**LANSING BOARD OF ZONING APPEALS**  
**Regular Meeting**  
**Thursday, December 11, 2025, 6:30 PM**  
**Neighborhood Empowerment Center**  
**600 W Maple Street, Lansing, MI 48906**

**A. BZA-4099.25, 809 E Michigan Avenue**

REQUESTED ACTION: Variances to the building height requirements, driveway location, required corner massing, setback from front property lines (build-to line), numerical parking restriction, and building entrance location.

2 FRONT ELEVATION

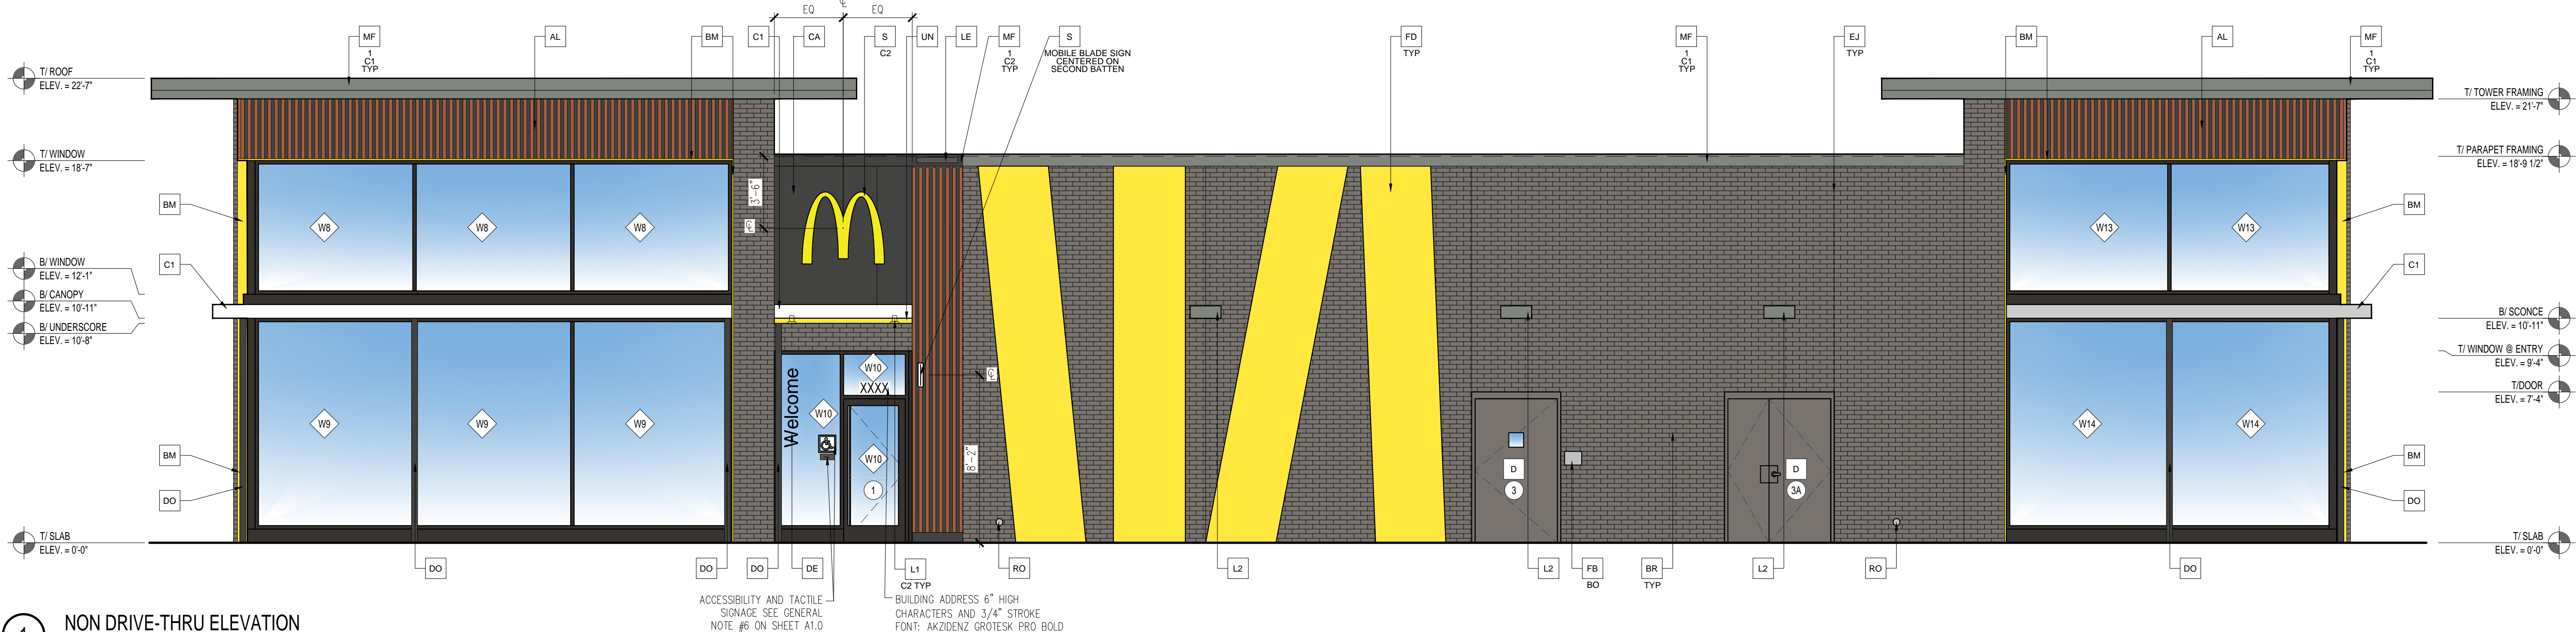
The primary concern with the proposal is that it is not designed to enhance the goals of the zoning ordinance and master plan to create a pedestrian-oriented/friendly environment along the E. Michigan Avenue corridor. There is no pedestrian entrance on the front wall of the building and the one pedestrian entrance to the building from the public sidewalk is located towards the north end of the west wall of the building along N. Hosmer. In addition, the site design will require pedestrians to walk a substantial distance to the building from most of the parking spaces with no designated walkways or controls to prevent conflicts with vehicular traffic within the site.

As described in the preceding paragraphs of this report, the proposed building and site design are not consistent with the intent and purpose of the master plan or the zoning ordinance and thus, approval of the variances could negatively impact future patterns of development by setting a precedent for future requests to vary the ordinance standards. The City's vision is to create an environment that encourages pedestrian activity, particularly in the downtown and surrounding commercial areas such as the E. Michigan Avenue corridor, Reo Town, Old Town and W. Saginaw Street where the majority of the buildings are located at or very close to the front property lines with the primary entrances on the front wall and parking lots in the rear. The proposed site has the back wall of the building facing E. Michigan Avenue with a 15-foot offset from the property line.
